GULMOHAR RESIDENCY

Details of Additions & Alterations

Flat No	H-303	Block no.	H
Flat Area	sft	Type	Deluxe / Luxury
Buyer Name	Mr. Gini Lanka.		
Phone No.	9030247457	Email	gini.lanka@gmail.com

WORKING PLAN-1360 SII-A2 TYPE

Changes in kitchen platform: (mark on plan)

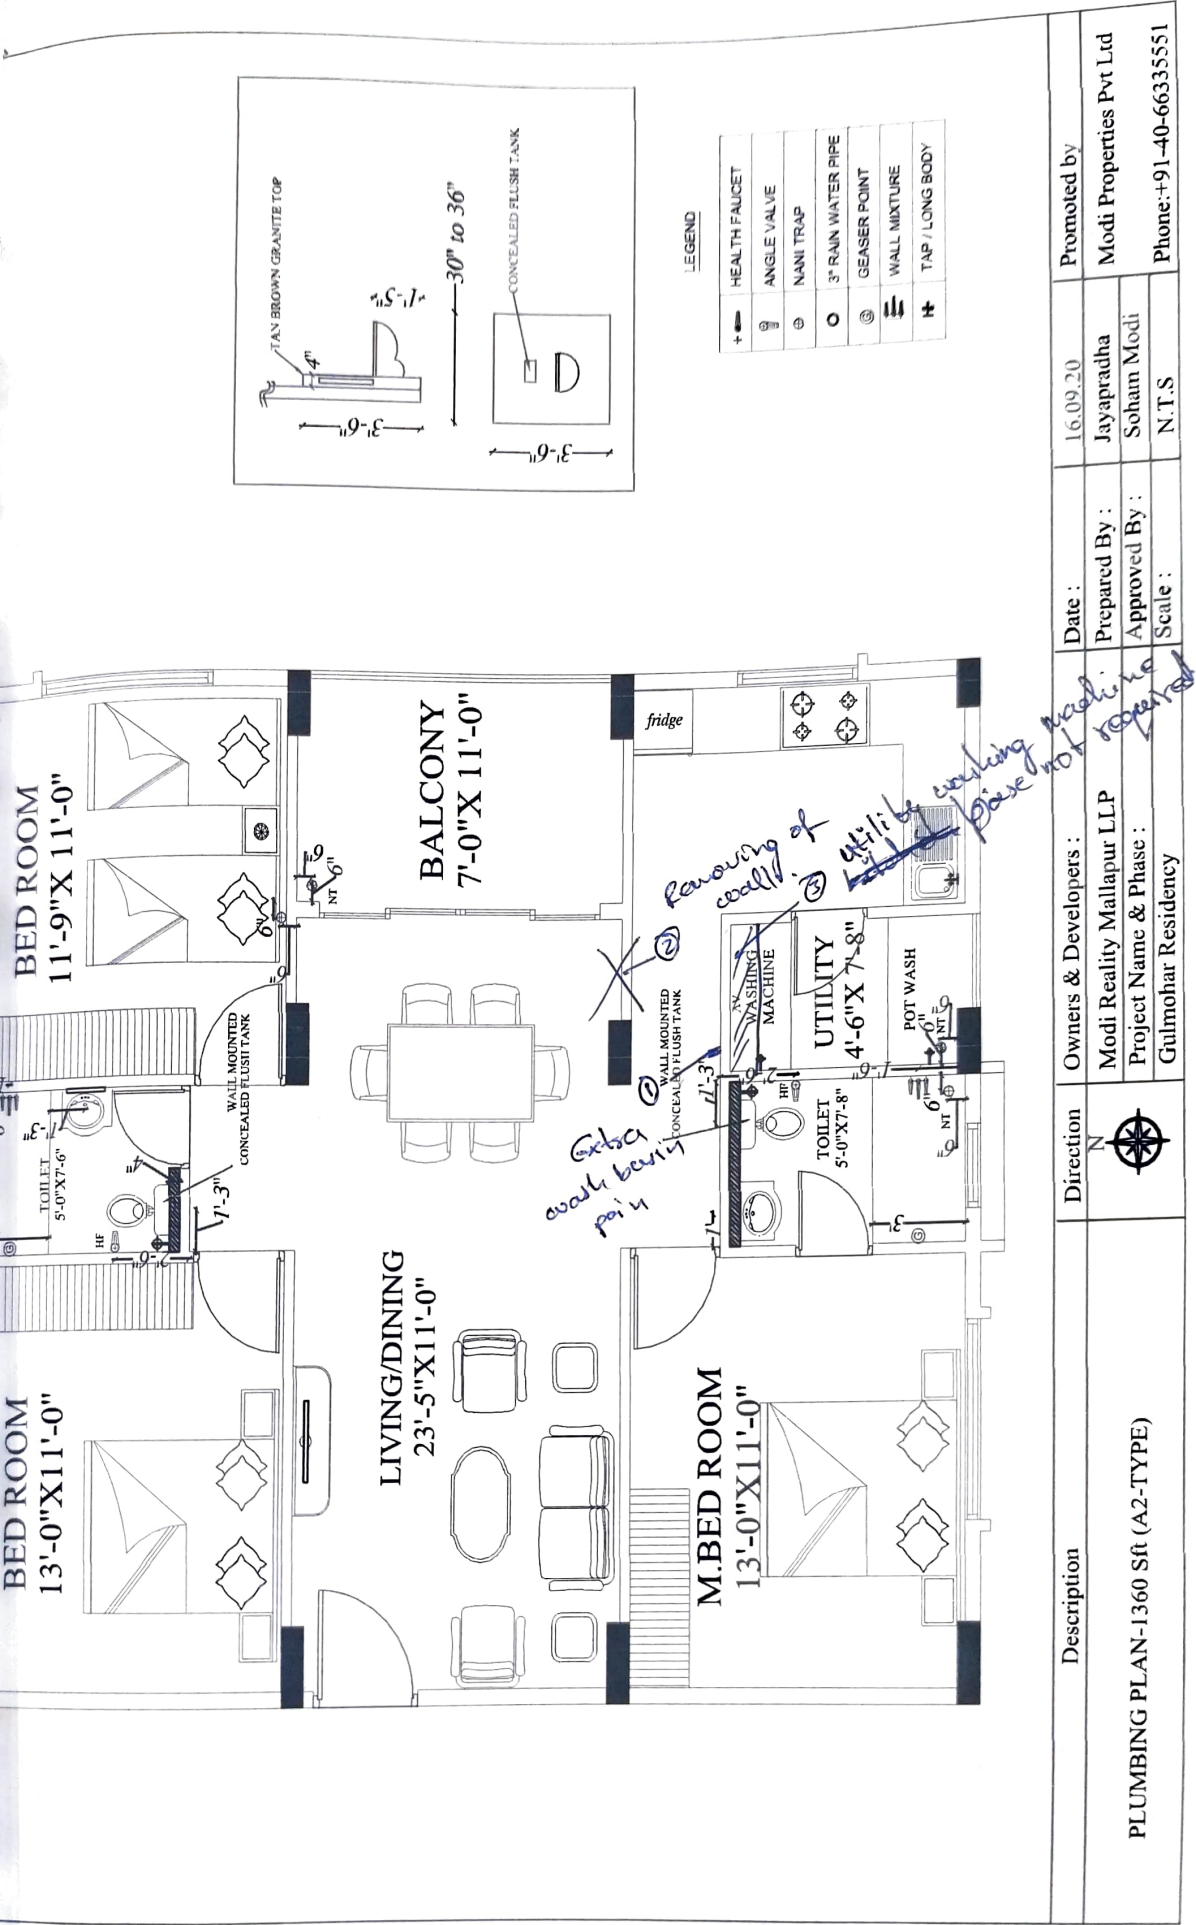
1) Kitchen a slab goes from wall to bridge.

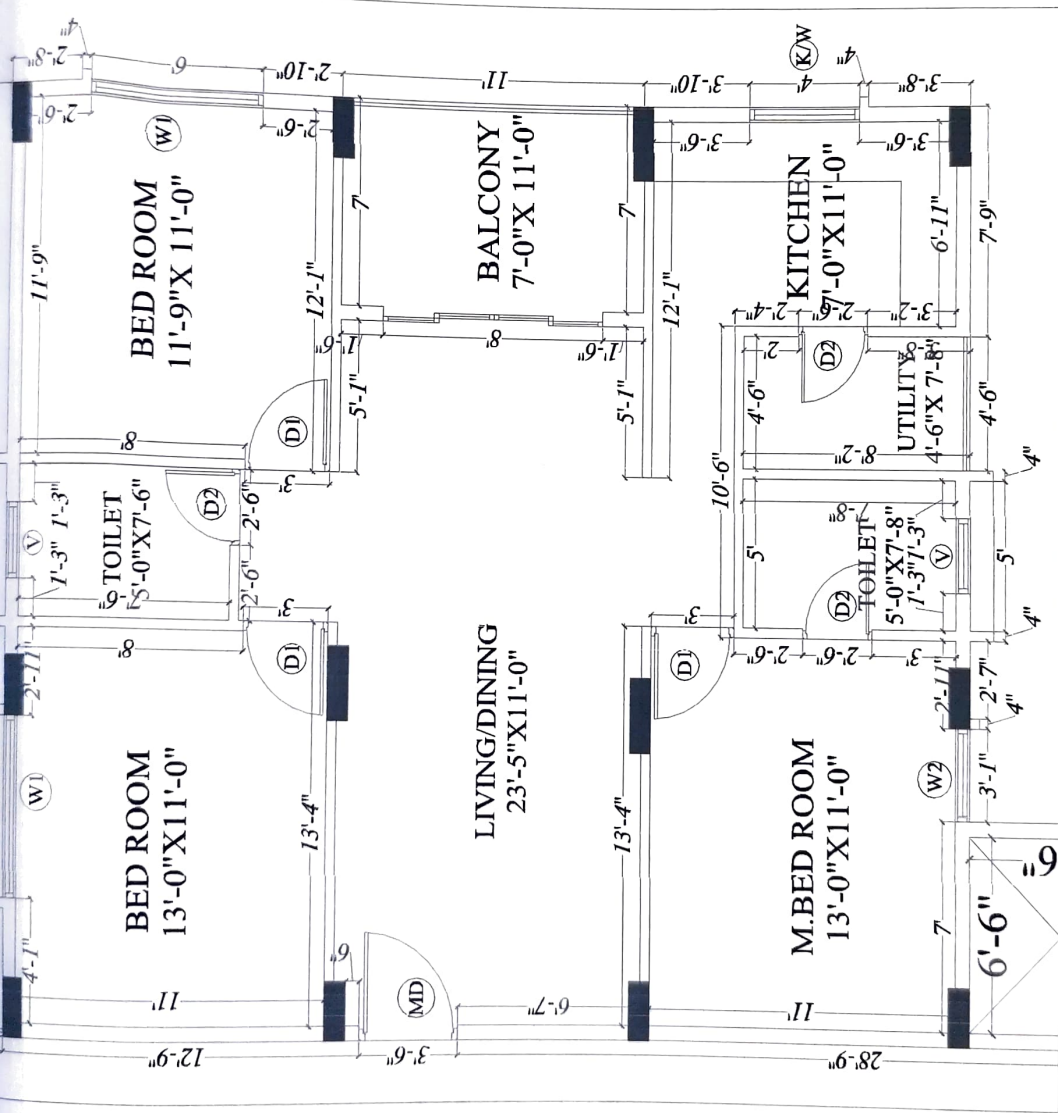
- 1) Extra Wash basin. point required as per plan. - (1)
- 2) Hall should be removed as per plan.
- 3) Utility crushing machine base not required.
- 4) Bath room glass partitions required.
- 5)
